SITE INSTRUCTION

PROJECT: HAMPTON MANOR
25 BAKER HILL BLVD
STOUFFVILLE, ONTARIO

SITE INSTRUCTION NO.: E-21

**1.0 Reference Drawings E-3A (Ground Floor Plan A - Electrical) Issued
E-3B (Ground Floor Plan B - Electrical)**

TITLE GROUND FLOOR PLAN - B ELECTRICAL			
PROJECT PROPOSED RESIDENTIAL DEVELOPMENT 25 BAKER HILL BLVD.			
DRAWN CM			
CHECKED MG			
SCALE 1:75			
DATE SEPT. 2015			
PROJECT 14-016			
DRAWING E-3B			
OF 12

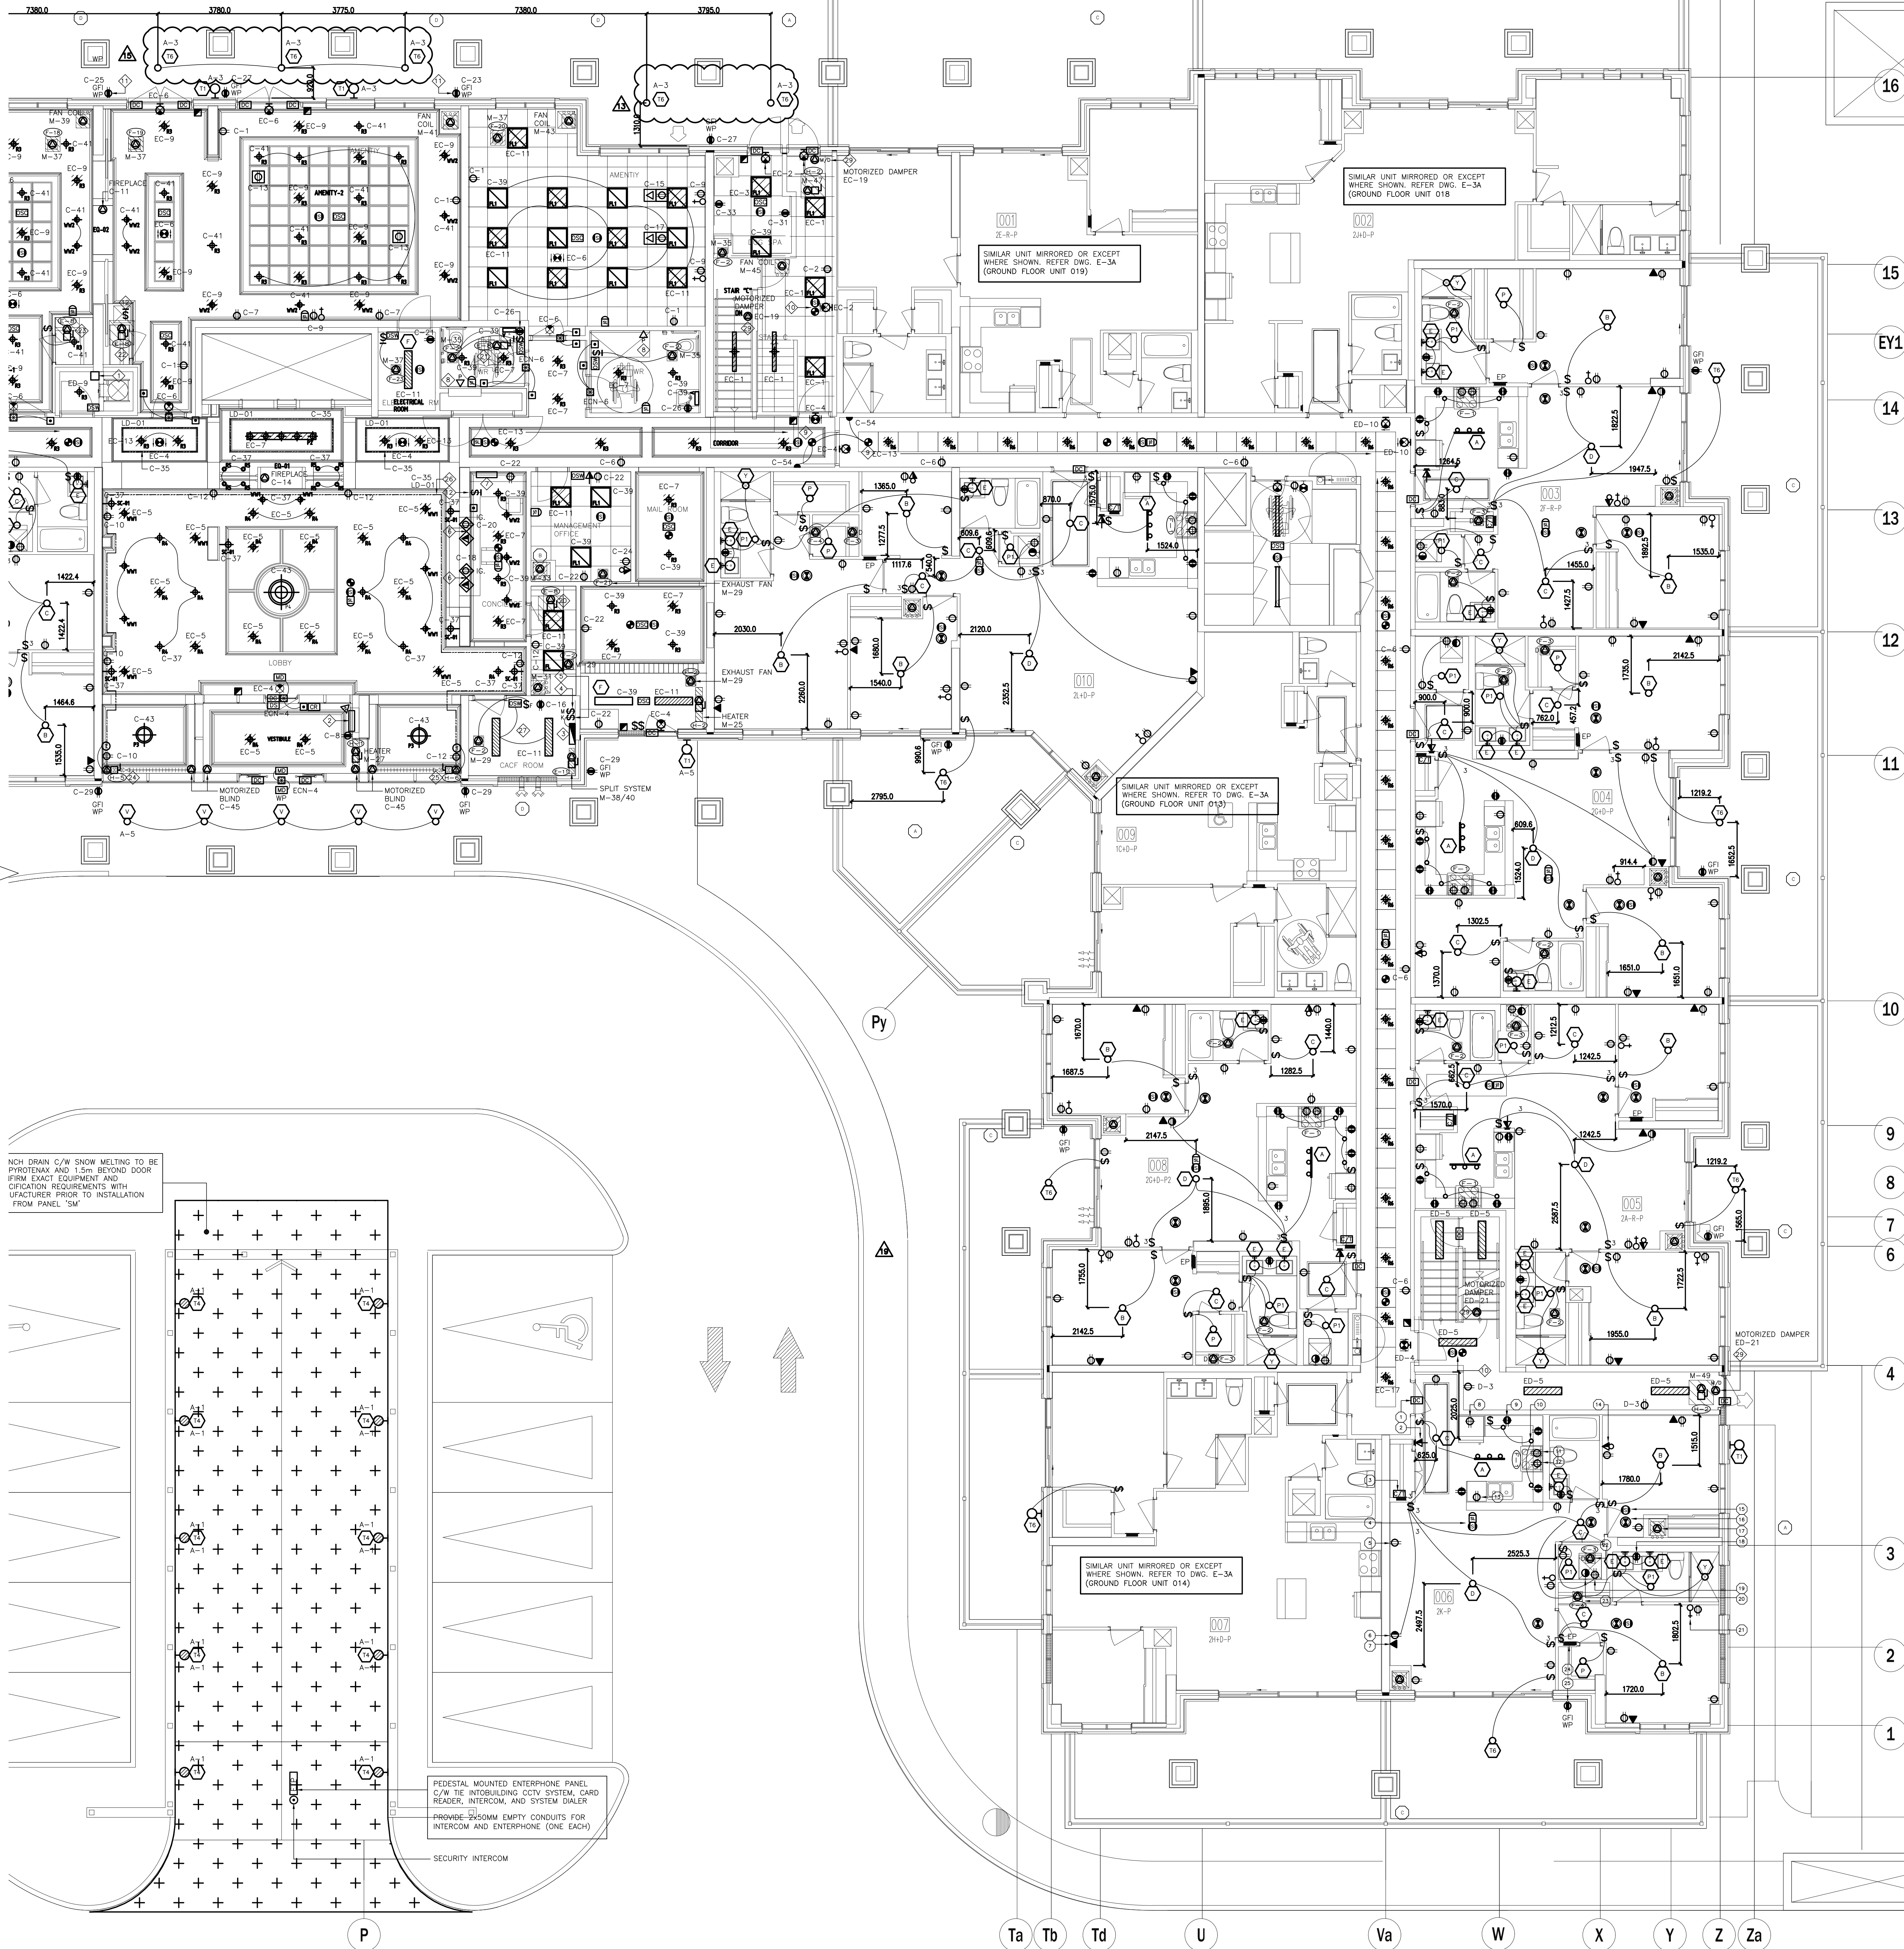
- 1.1 Revise: Exterior lighting fixture layout in amenity area as shown.
Lighting fixture to be surface mount type 'T6'.
- 1.2 Revise: Kitchen electrical layout and notes as shown, connect stove to
circuit: C: 48/50 with a 208V, 2P, 40A breaker.
